IEEE 802.3 Ethernet Working Group  
Liaison Communication

Subject: Reply to Incoming Liaison JTC 1/SC 25/3073/INF

We would like to thank you for the preview of JTC1-SC25/3068/CD, ISO/IEC 11801-1/AMD1 ED1. The IEEE 802.3 Working Group (the WG) has some comments on the draft:

# PSANEXT SPEC

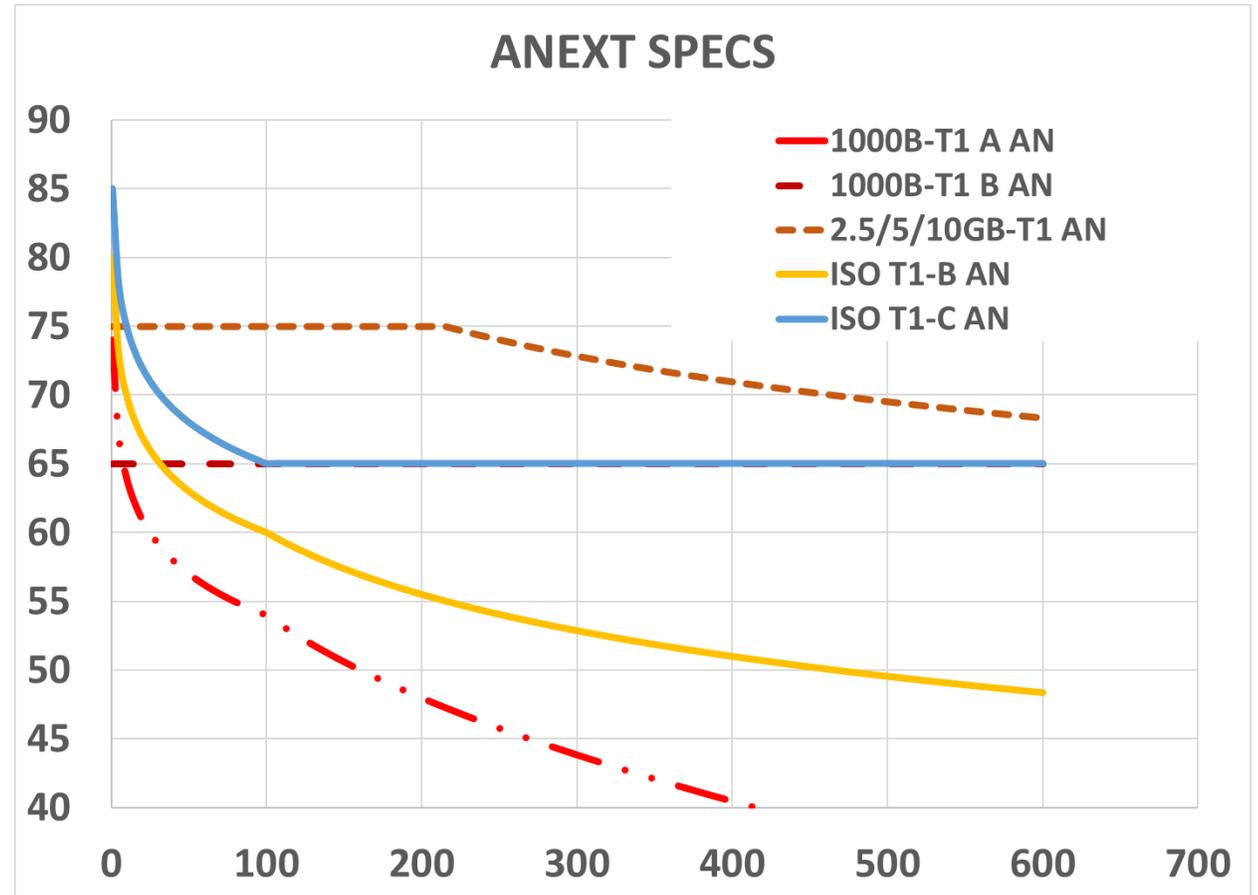
- T1-B ANEXT:
  - Meets 1000BASE-T1 seg A
  - Fails 1000BASE-T1 seg B, 2.5/5/10GBASE-T1
- T1-C ANEXT
  - Meets 1000BASE-T1 seg A, B
    - But is excessive on frequency
  - Fails 2.5/5/10GBASE-T1

# PSAACR-F SPEC

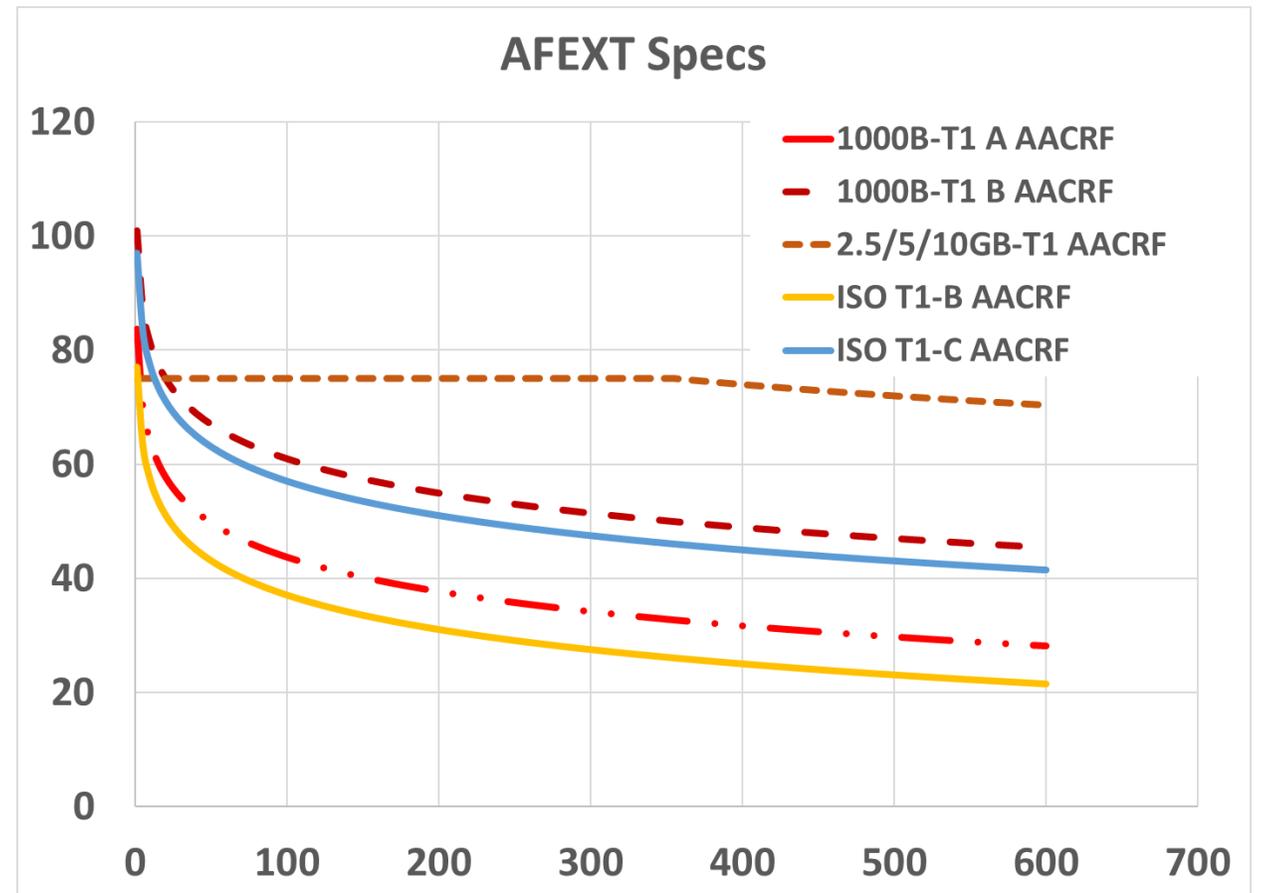
- T1-B PSAACR-F:
  - Fails 1000BASE-T1 seg A
  - Fails 1000BASE-T1 seg B, 2.5/5/10GBASE-T1
- T1-C PSAACR-F:
  - Meets 1000BASE-T1 seg A
    - But is excessive on frequency
  - Fails 1000BASE-T1 seg B, 2.5/5/10GBASE-T1

Note: neither specification defines length scaling for this parameter, so none is applied.

- ISO T1-B has frequency range fitting 1000BASE-T1 applications, but has insufficient PSAACR-F specifications
  - Noting that T1-B PSAACR-F is marked ffs, recommend aligning to meet 1000BASE-T1 link segment A specifications (Eqn 97-24 in IEEE P802.3dc D3.0)
